REMEDIATION SYSTEM EVALUATION

DOUGLAS ROAD LANDFILL
ST. JOSEPH COUNTY, INDIANA

Report of the Remediation System Evaluation,
Site Visit Conducted at the Douglas Road Landfill Superfund Site
October 29, 2003

EPA 542-R-04-031
February 2004
www.epa.gov/tio
clu-in.org/optimization

FIGURE 1-3. MONITORING LOCATIONS WHERE ARSENIC EXCEEDED PRGs IN MAY 2003.

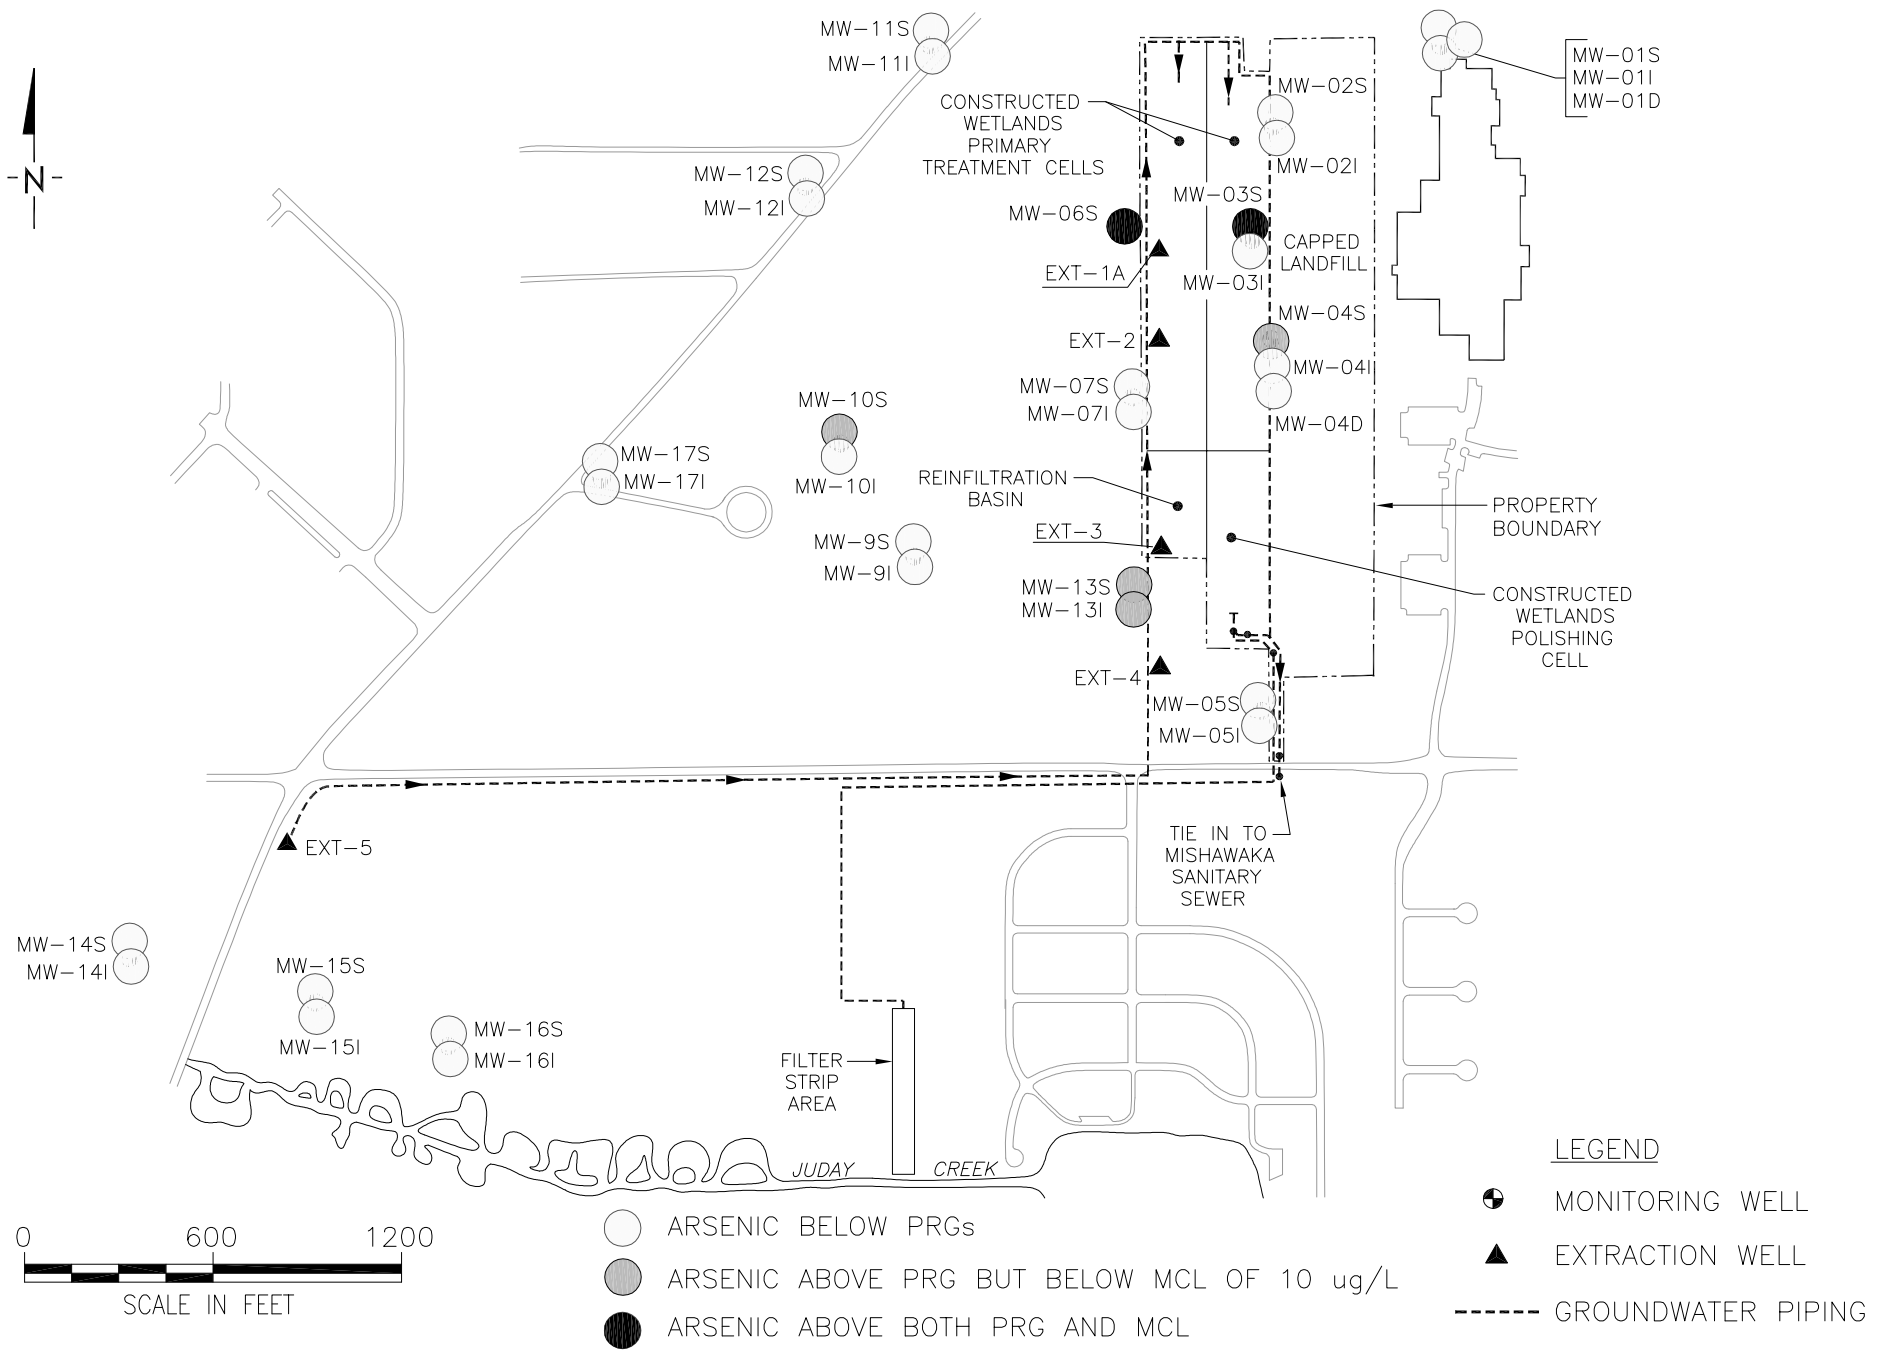
Figure 1-3 presents the extent of arsenic above PRGs based on the May 2003 sampling event. The most significant arsenic impacts are at MW-3S (15 ug/L), which is located less than 100 feet downgradient of the landfill, and MW-6S (29 ug/L), which is located less than 500 feet downgradient of the landfill. The arsenic impacts at MW-6S and MW-3S are relatively stable, and the other arsenic impacts are above the PRGs but are below 5 ug/L (the MCL is 10 ug/L).

FIGURE 1-4. MONITORING LOCATIONS WHERE VOCs EXCEED PRGs AND/OR MCLs IN MAY 2003.

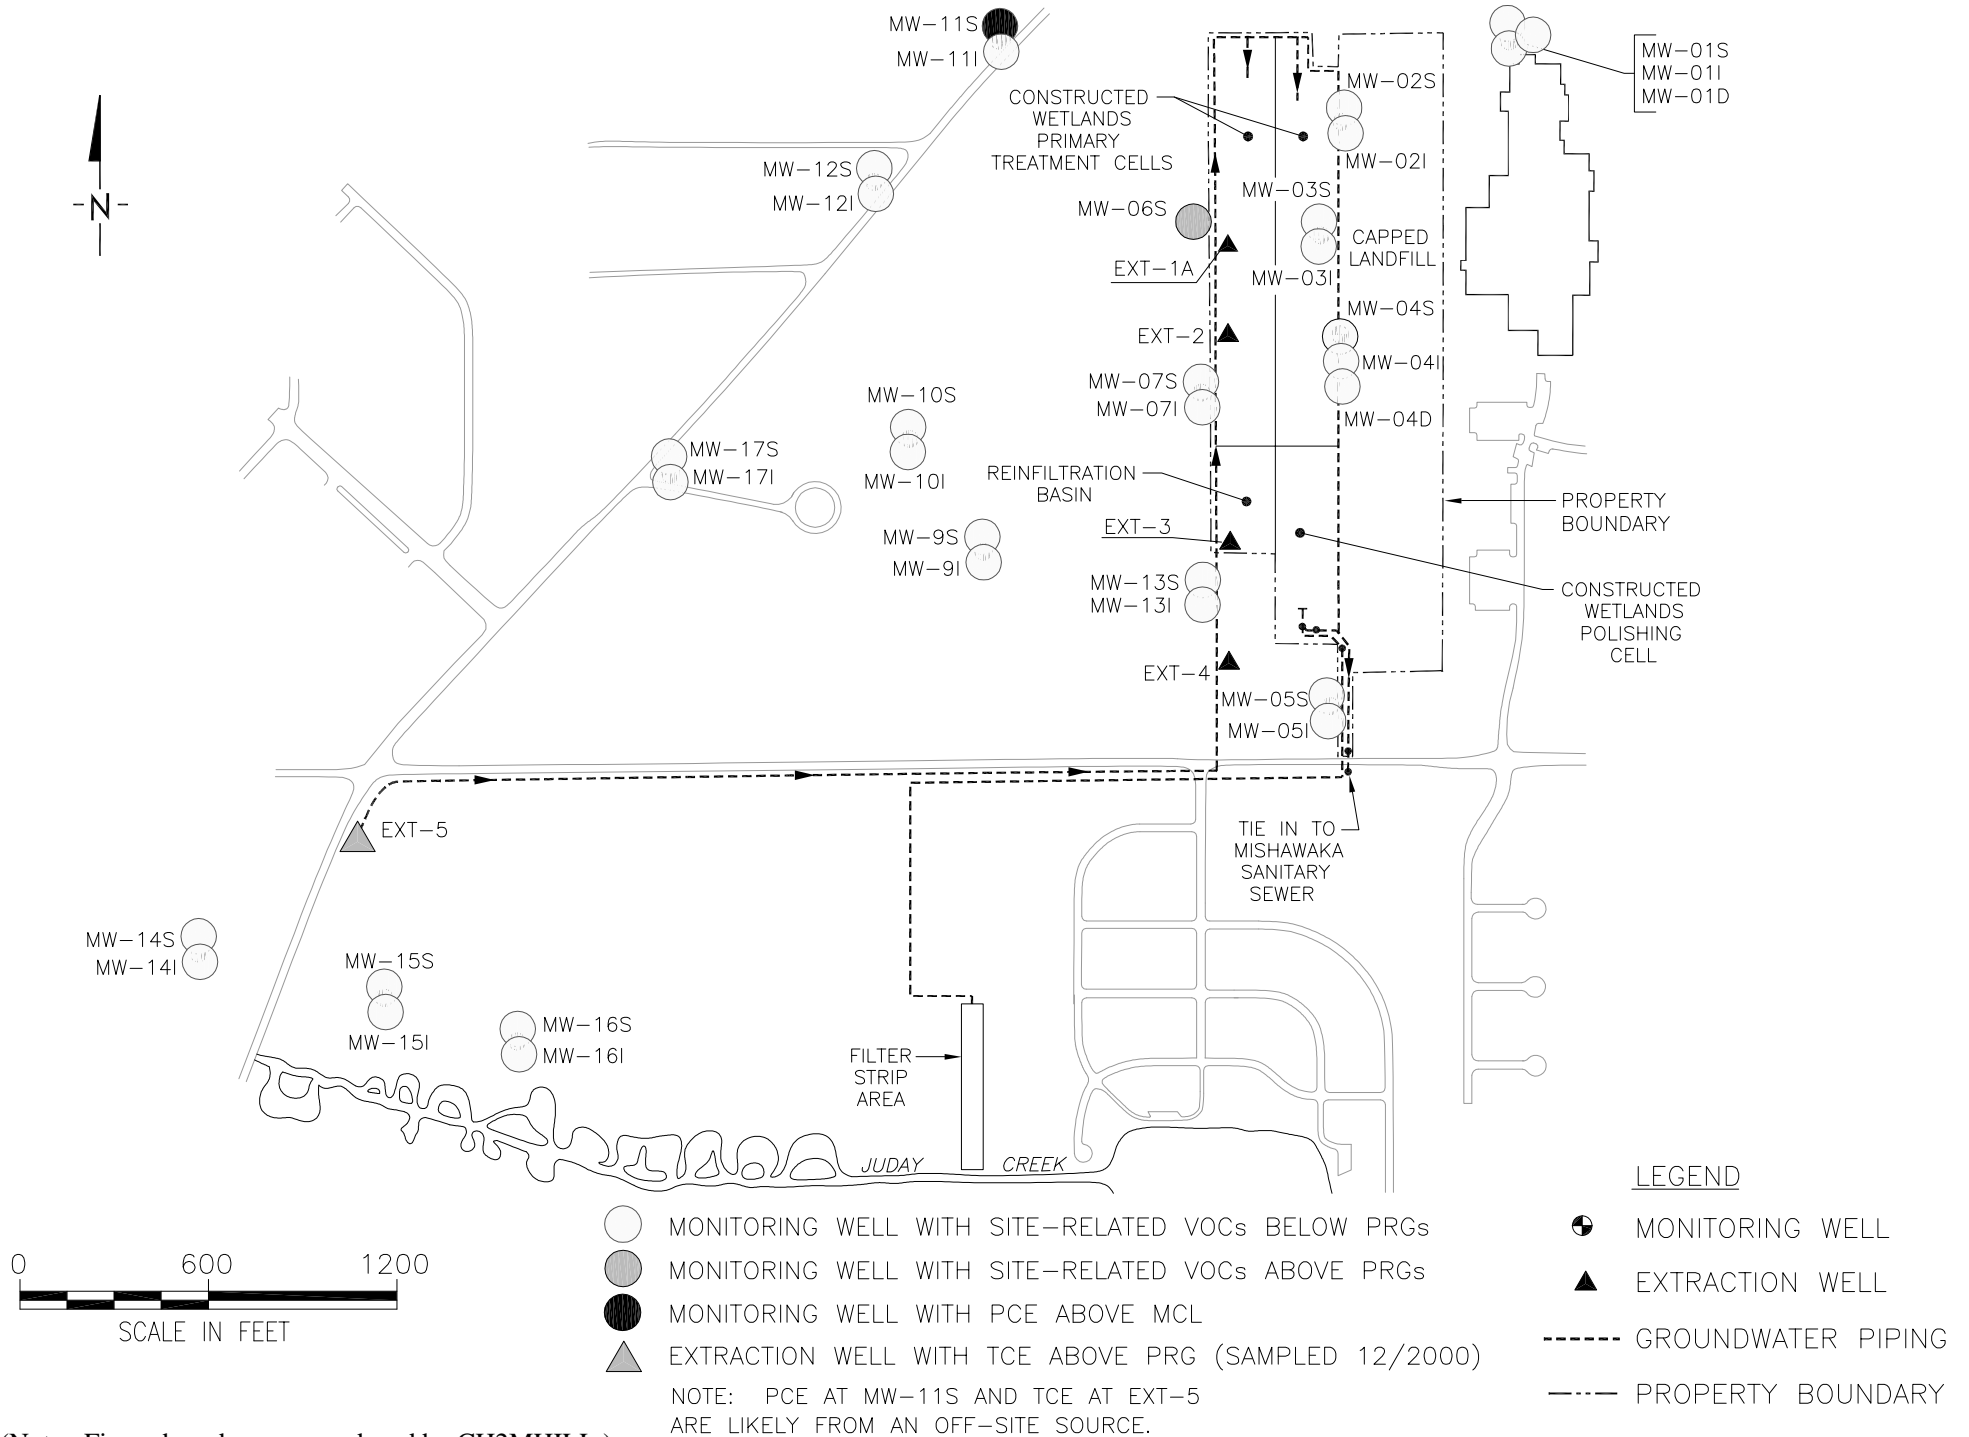
Figure 1-4 presents the monitoring locations where VOCs were above PRGs and/or MCLs based on the May 2003 sampling event. VOC concentrations have remained relatively stable at MW-6S. Historical sampling of monitoring wells indicates a significant decrease in VOC concentrations in MW-3S, which previously had the highest concentrations found at the site. Total VOC concentrations (not including tetrahydrofuran) have decreased from 61.6 ug/l in November 1999 and 128 ug/l in November 2000 to 4.2 ug/l in May 2003.
